# ADDENDUM NO. 3

### November 28, 2022

# JACKSON ELEMENTARY SCHOOL RENOVATIONS Valparaiso, IN 46304

This Addendum consists of page ADD 3-1 and attached Addendum No. 3 from Gibraltar Design dated November 23, 2022 and consisting of 7 pages and 42 drawings.

MV101

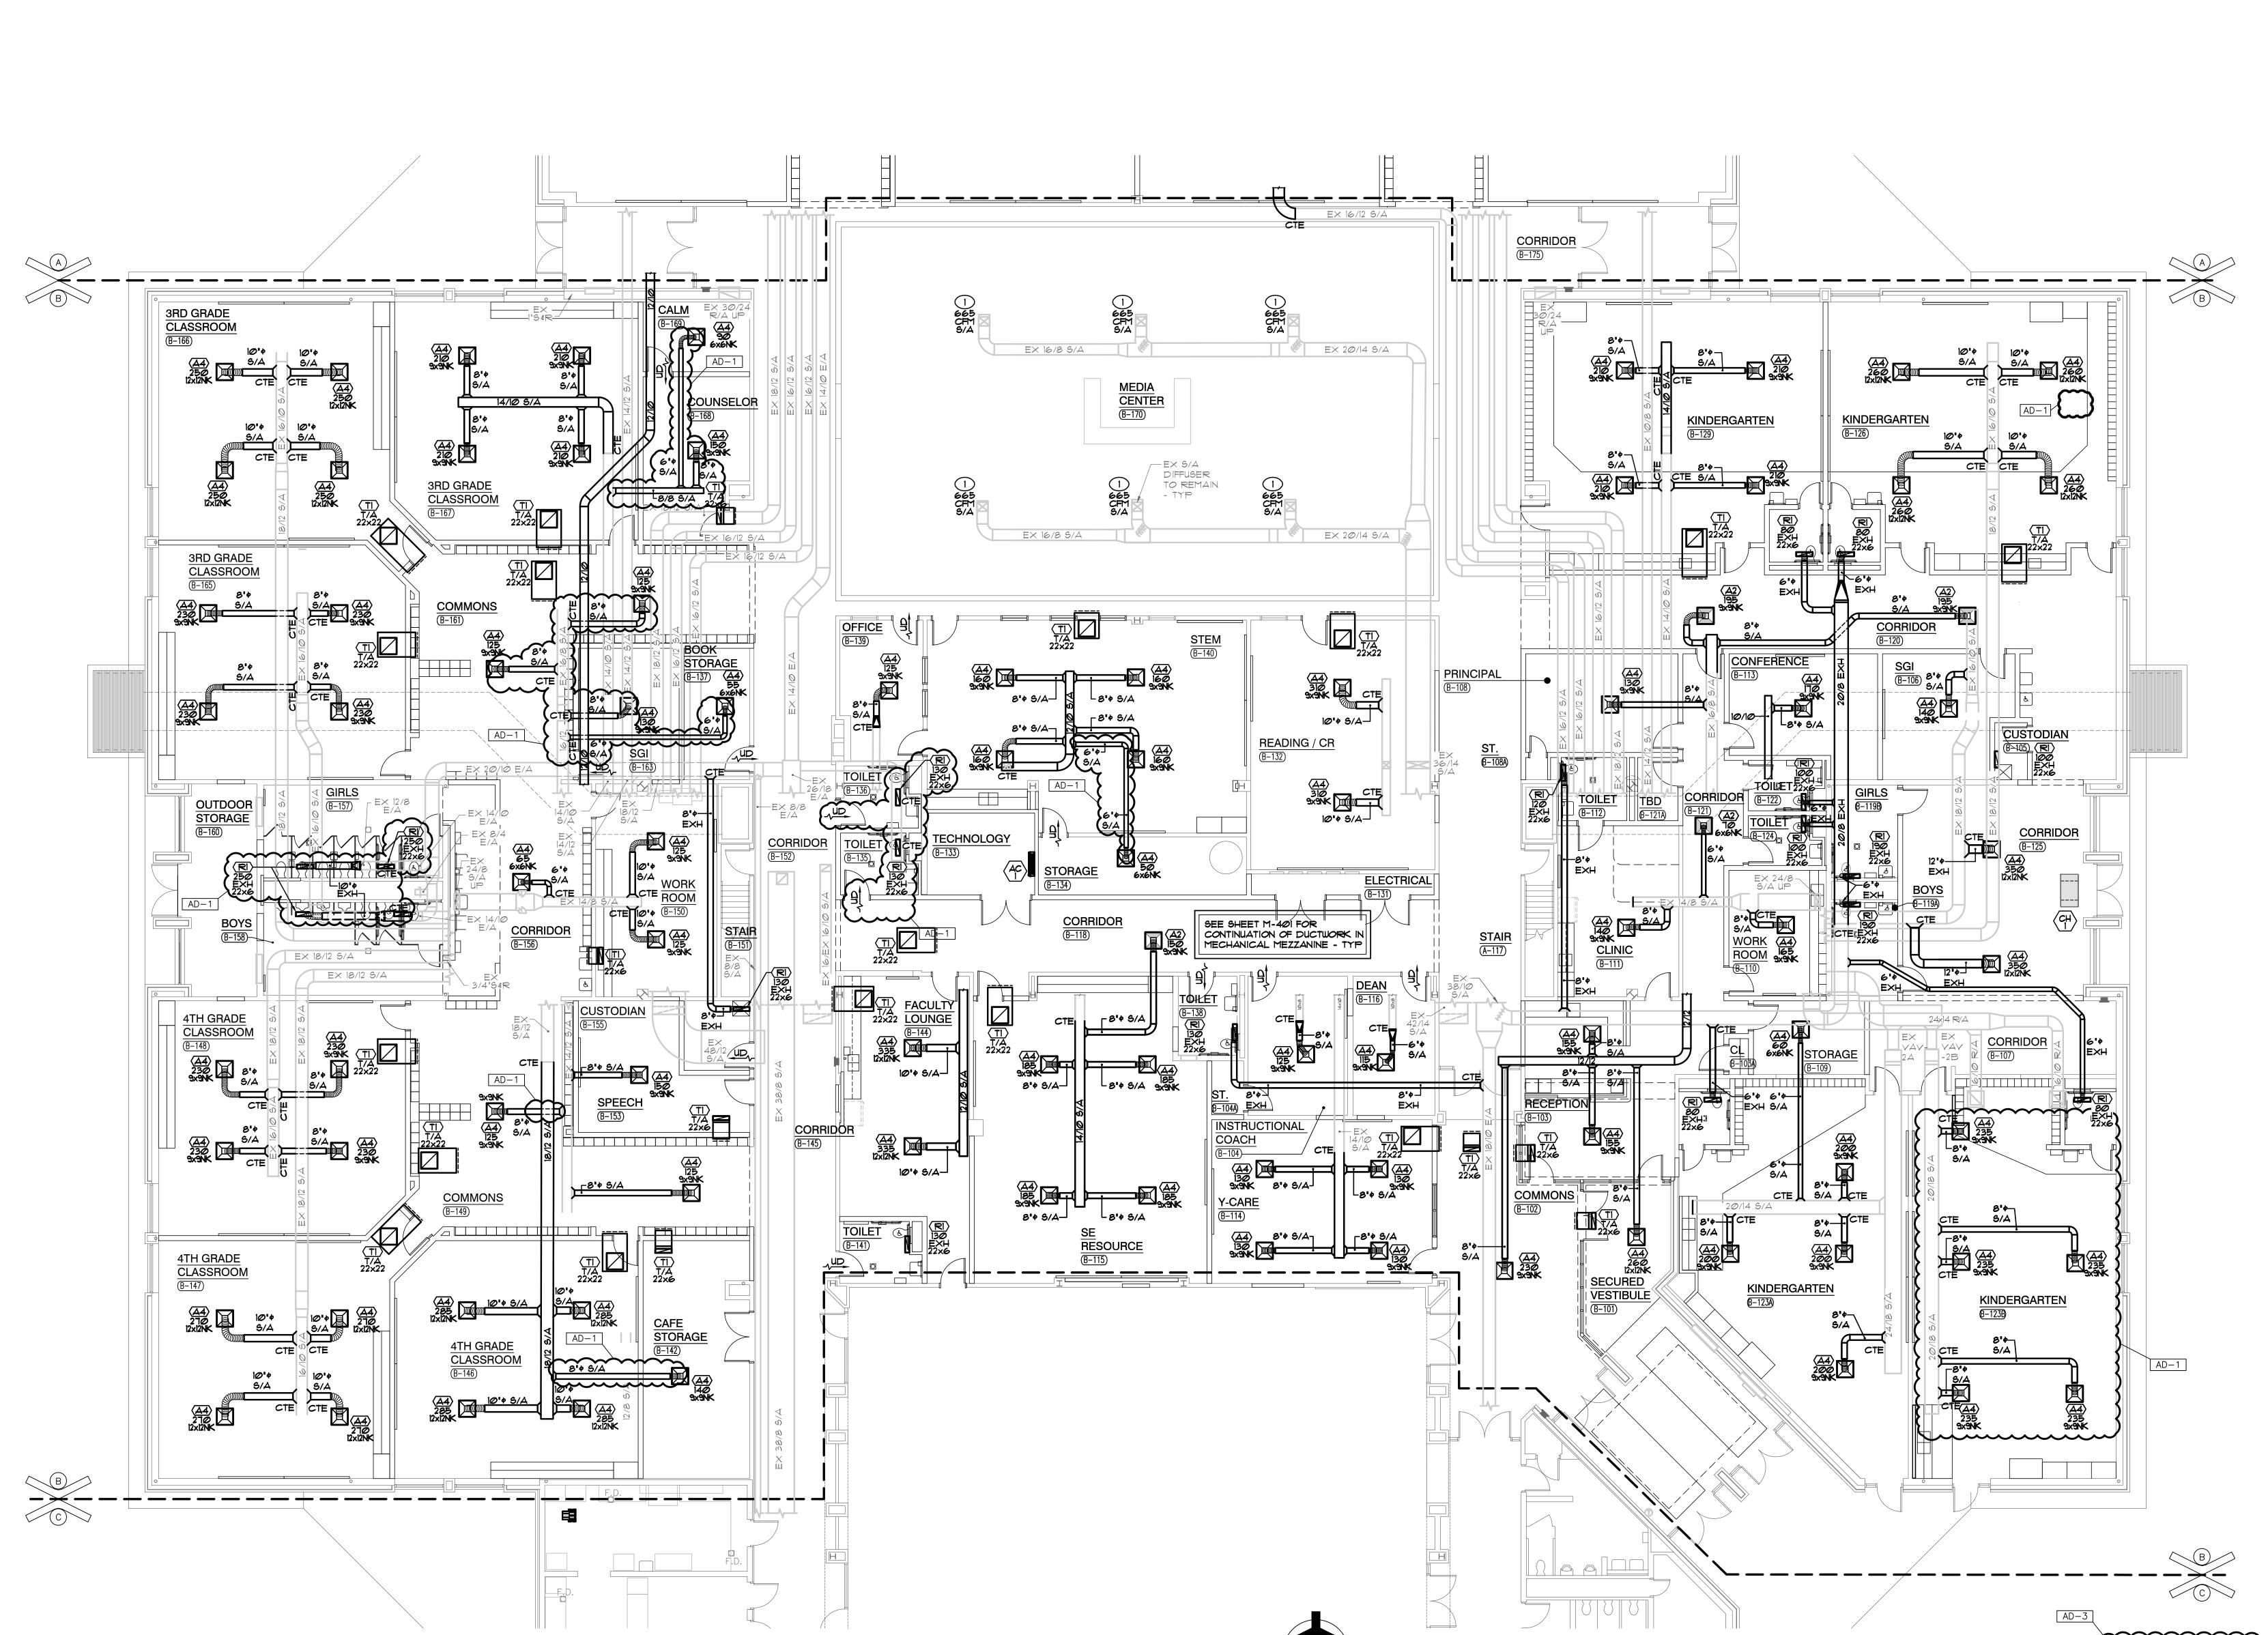
- A. Refer to revised full size drawing, included in this Addendum, for the following revisions:
  - 1. Added transfer/relief air.
  - 2. Added exhaust to custodian.

MV103

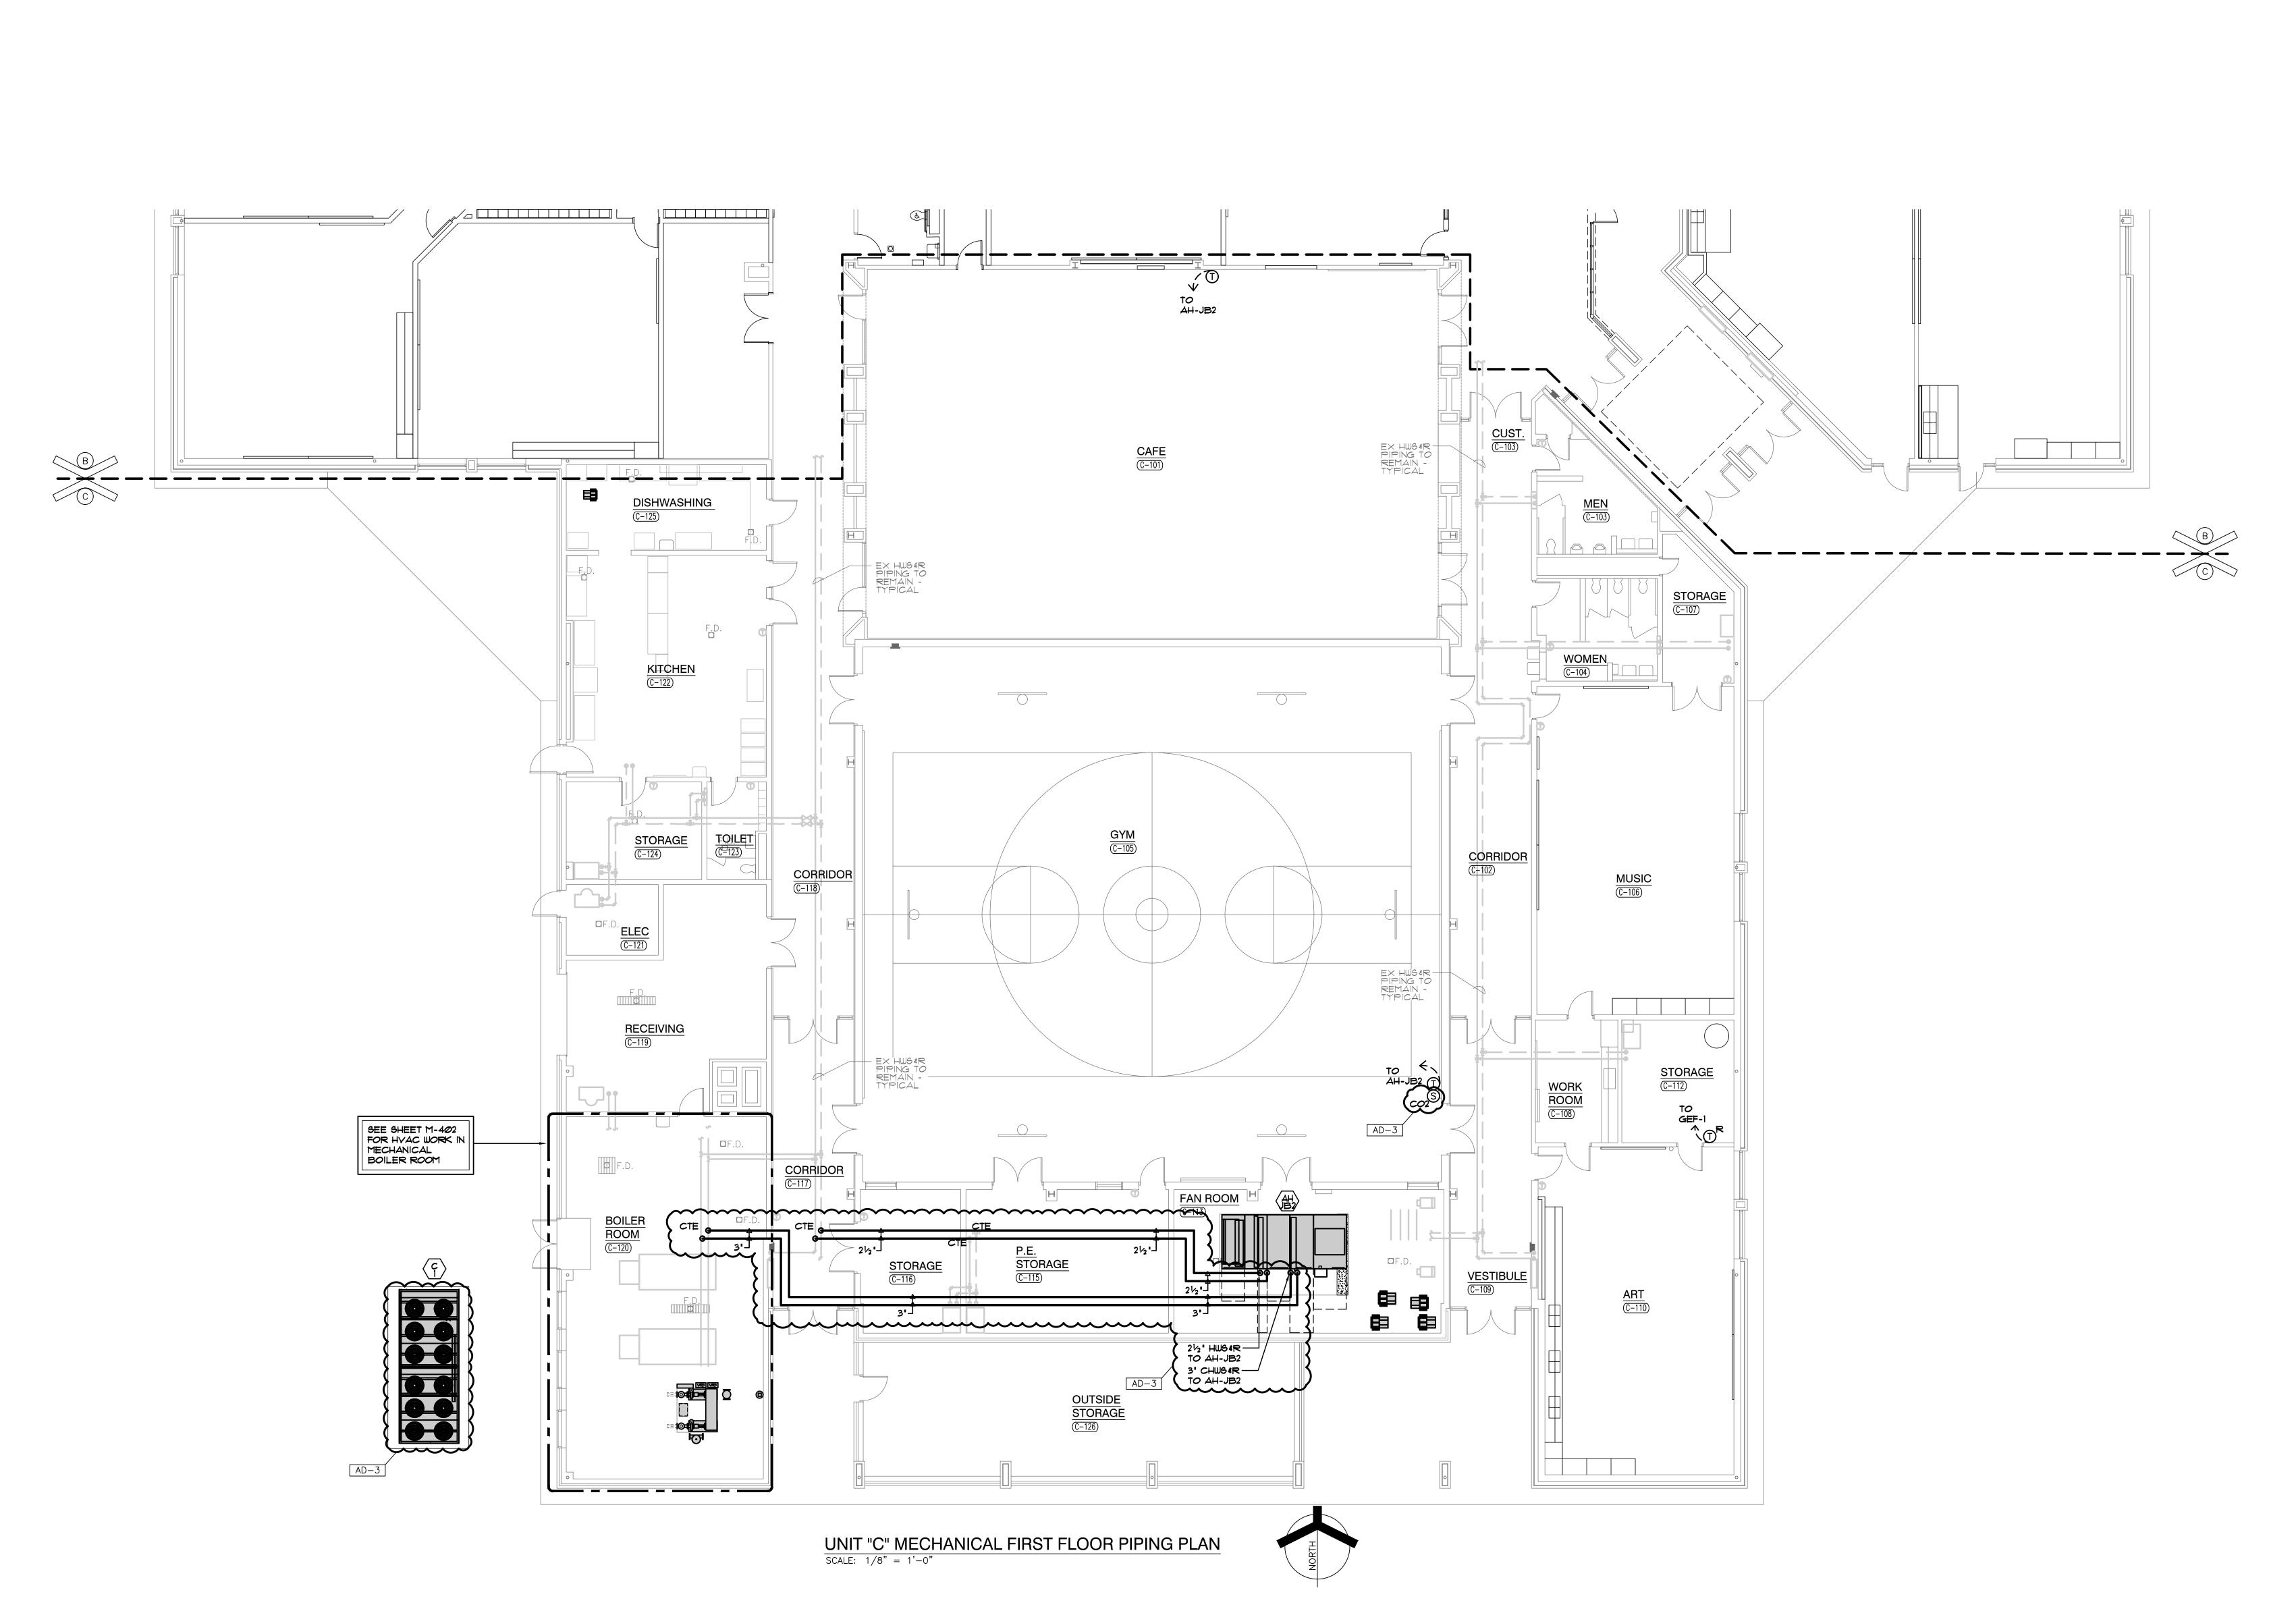
A. Refer to revised full size drawing, included in this Addendum, for new exhaust fans added.

MP103

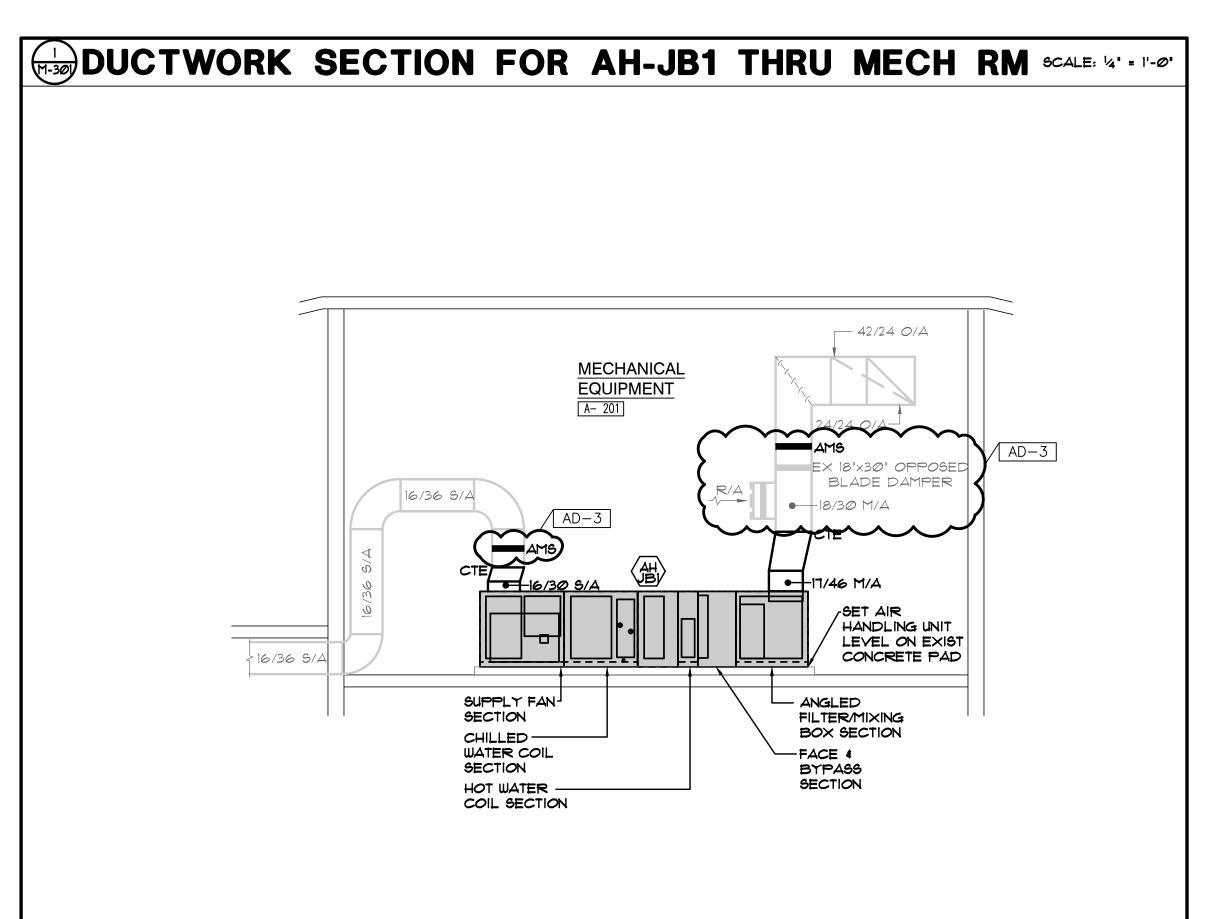
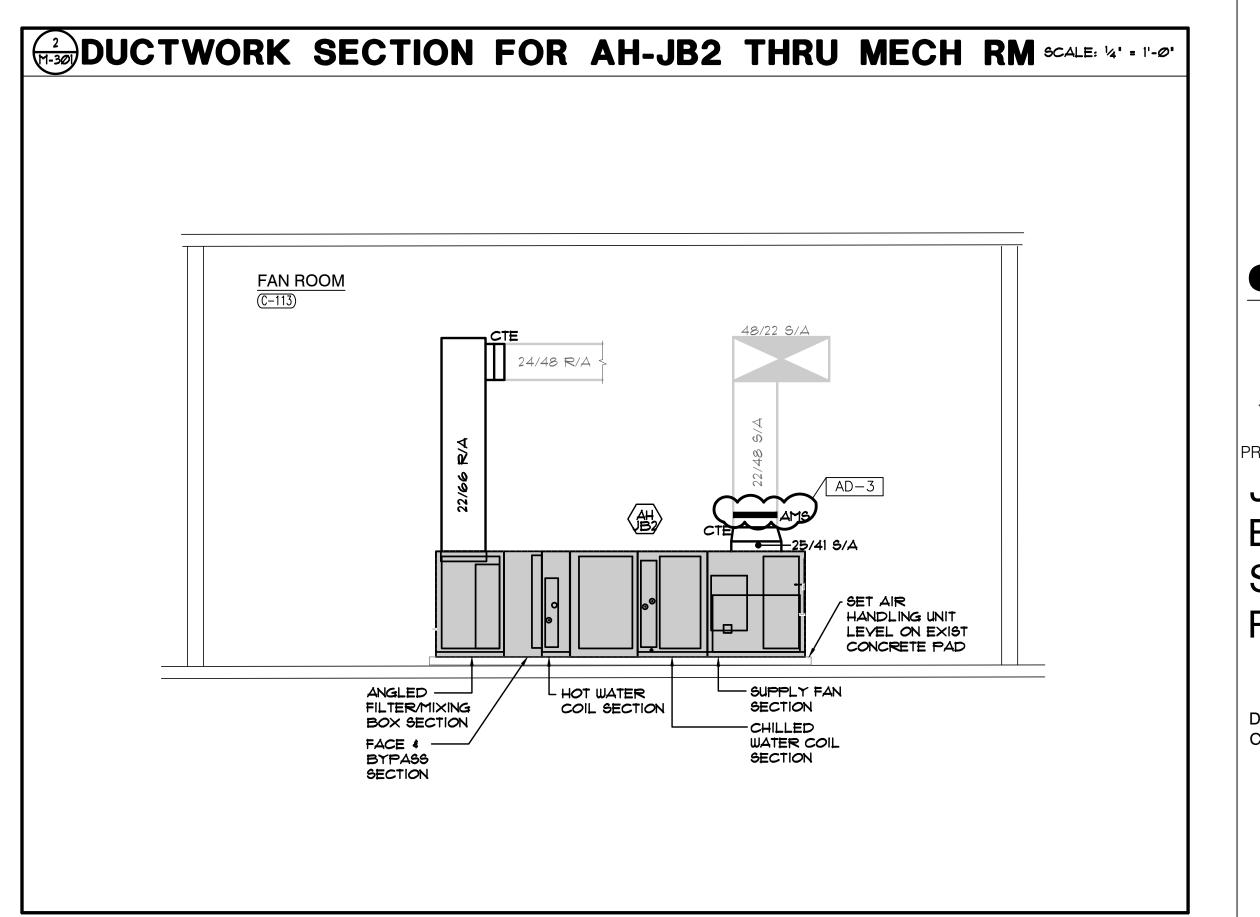
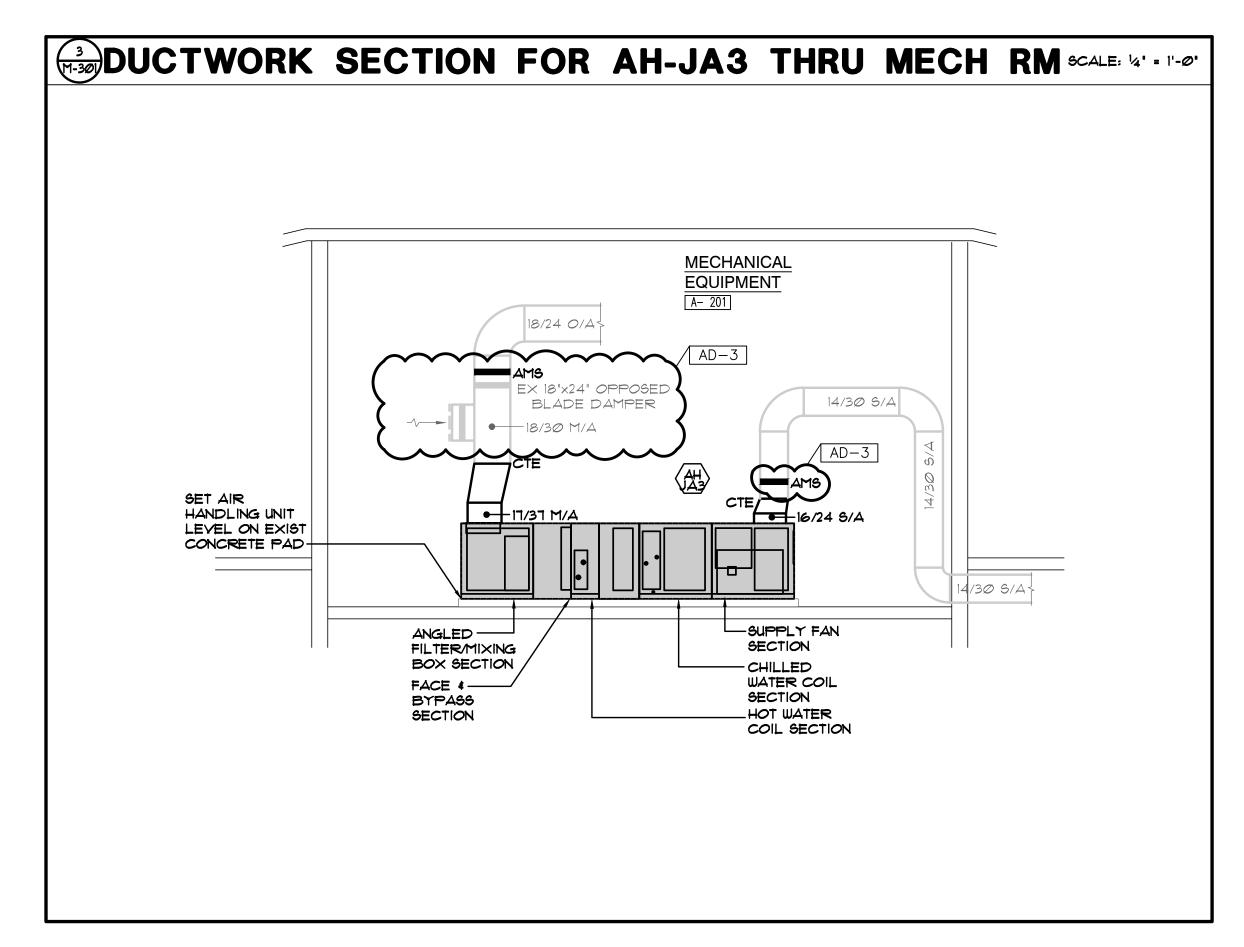
- A. Refer to revised full size drawing, included in this Addendum, for the following revisions:
  - 1. Added hot water and chilled water piping.
  - 2. Modified chiller location to existing concrete pad.
